CALCULATION/PROBLEM COVER SHEET

Calculation/Problem No: ROTC-06

Title: Multimode Factor Evaluation Train C

Client: TUGCo Project: Comanche Peak

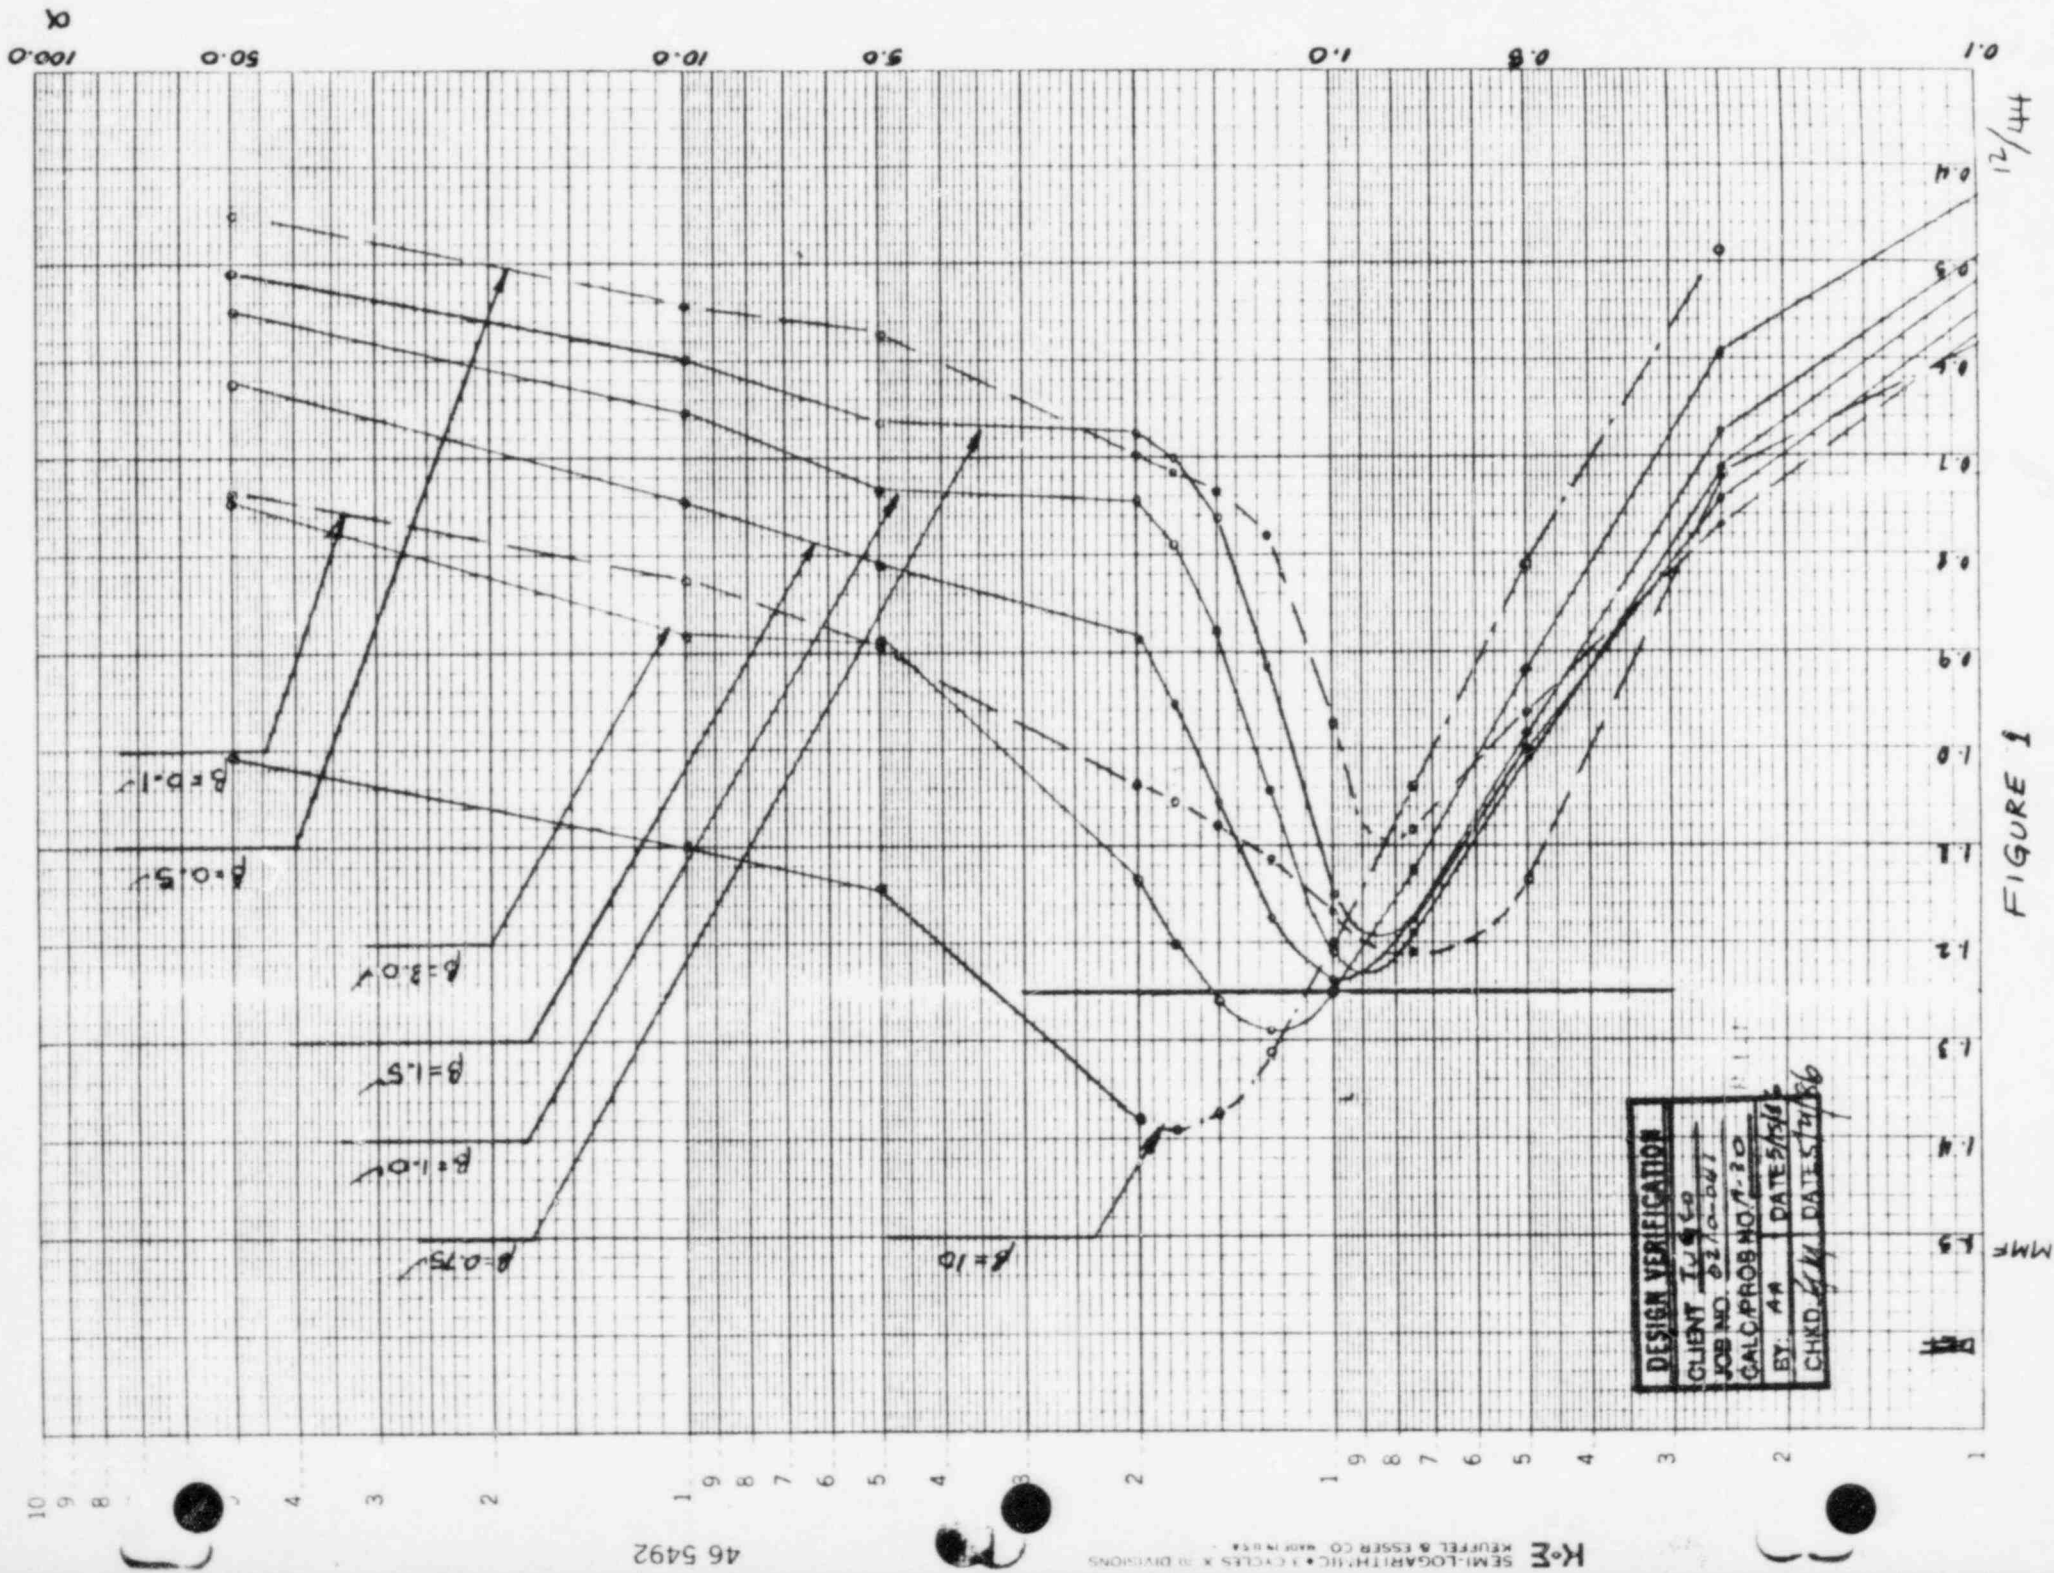
Figure 1 shows the variation of the DLF with the relative stiffness of the tray. The $\beta = 0.1$ curve does not follow the trend of the rest of the curves, i.e., obtain increased DLFs with increasing β . In the case of a very stiff support ($\beta < 0.1$) is it possible that the DLF will considerably exceed the 1.25 value?

The model studied in Figure 1 of calculation file was re-studied for the case of β equal to 0.01. The evaluated DFL for this case is $478.5/605 = 0.79$. Actually two runs were made; one for $K_{supp} = 10,000$ lb/in, $I_{beam} = 0.0268$ in⁴ and one for $K_{supp} = 1,000,000$ lb/in, $I_{beam} = 2.68$ in⁴. In both cases, the DFL was the same.

To study the case $\beta = 0.01$, two runs were made

ROTC-06-02 $K_{supp} = 10,000$ lb/in $I_{beam} = 0.0268$ in⁴

ROTC-06-03 $K_{supp} = 1,000,000$ lb/in $I_{beam} = 2.68$ in⁴

In both cases

$R_{dyn} = 478.5$ lb

$R_{static} = (72 \times 0.0151 + 0.479) 386.4 = 605$ lb

$DFL = 478.5/605 = 0.79$
